DUKE POWER COMPANY
OCONEE NUCLEAR STATION

PROPOSED TECHNICAL SPECIFICATIONS

Figure 2.1-1
Variable Low Pressure
Protective Limits

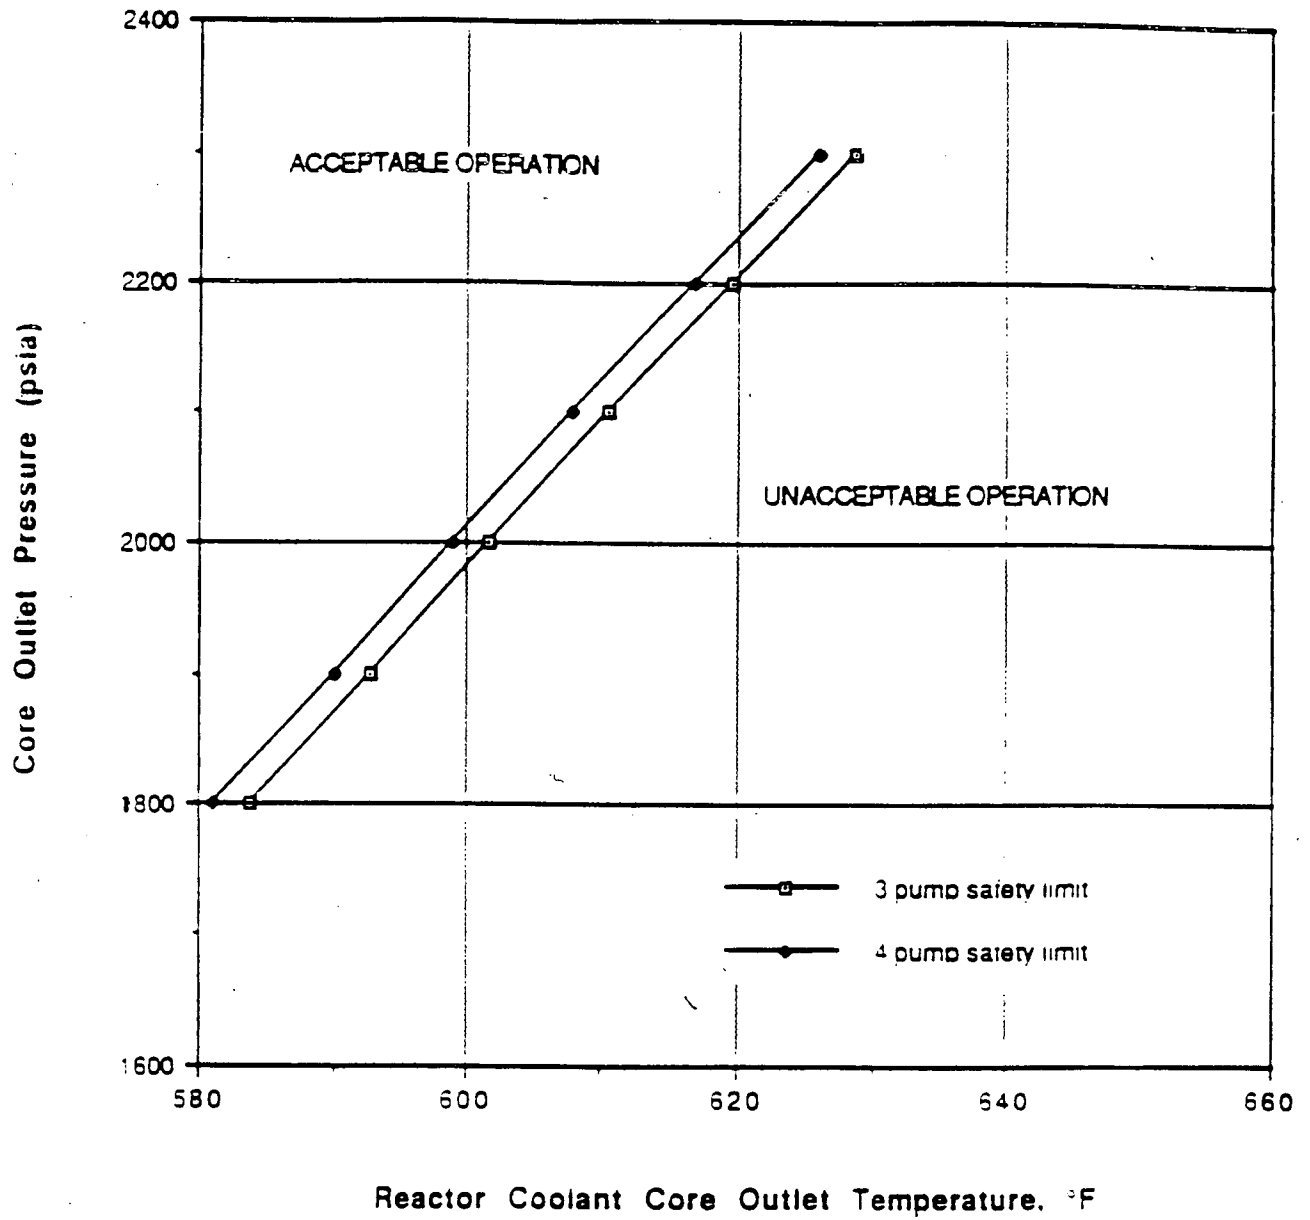
The curve presented in Figure 2.1-1 represents the conditions at which the minimum allowable DNBR is predicted to occur for the limiting combination of thermal power and number of operating reactor coolant pumps. This curve is based upon the design nuclear peaking factors provided in the Core Operating Limits Report.

Figure 2.1-2
 Axial Power
 Imbalance Protective Limits

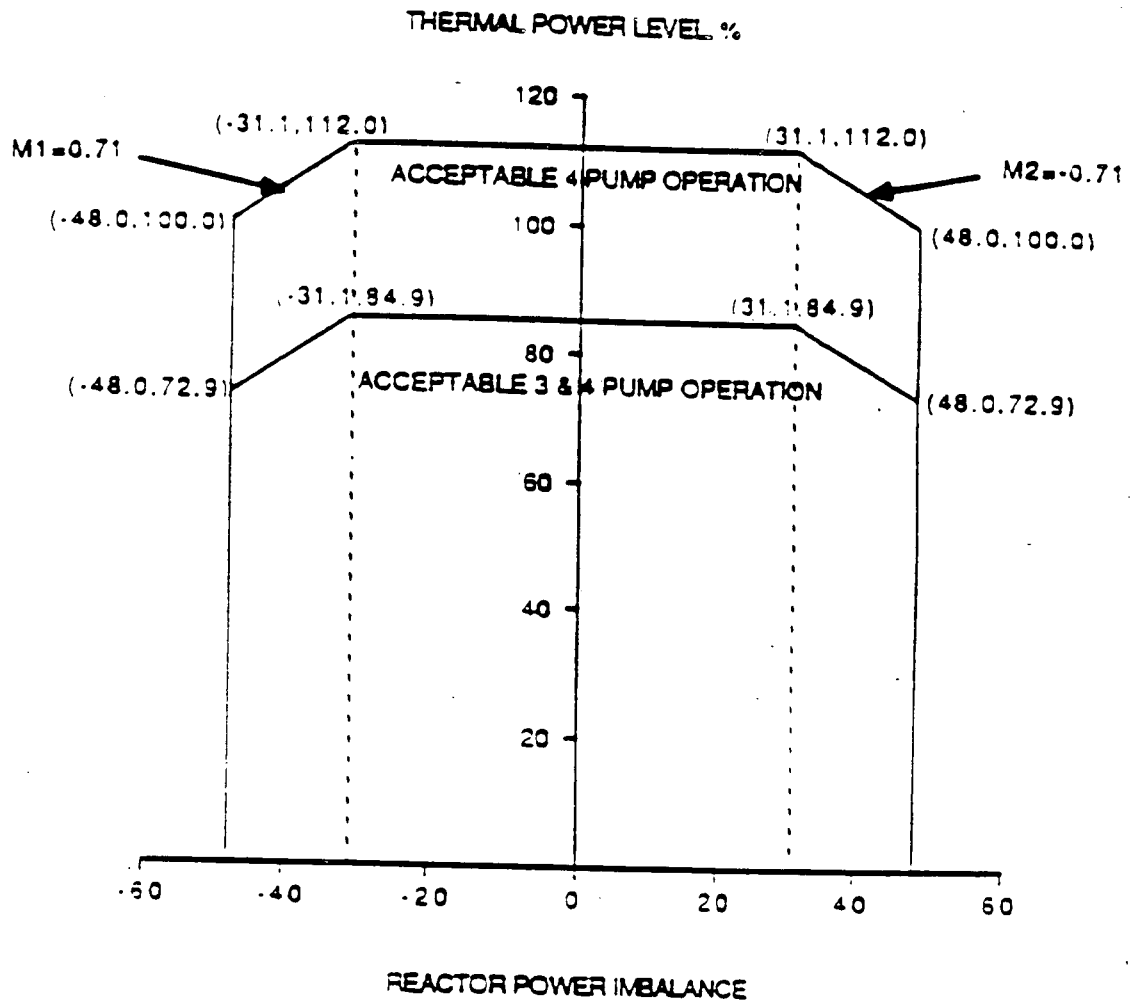
Since power peaking is not a directly measurable quantity, DNBR limited power peaks and fuel melt limited power peaks are separately correlated to measurable reactor power and power imbalance. The reactor power imbalance limits, Figure 2.1-2, define the values of reactor power as a function of axial imbalance that correspond to the more restrictive of two thermal limits - MDNBR equal to the DNBR limit or the linear heat rate equal to the centerline fuel melt limit.

The core protection safety limits are based on an RCS flow less than or equal to 385,440 gpm (4 pump operation). Three pump operation is analyzed assuming 74.7 percent of four pump flow. The maximum thermal power for three pump operation is provided in Figure 2.1-2.
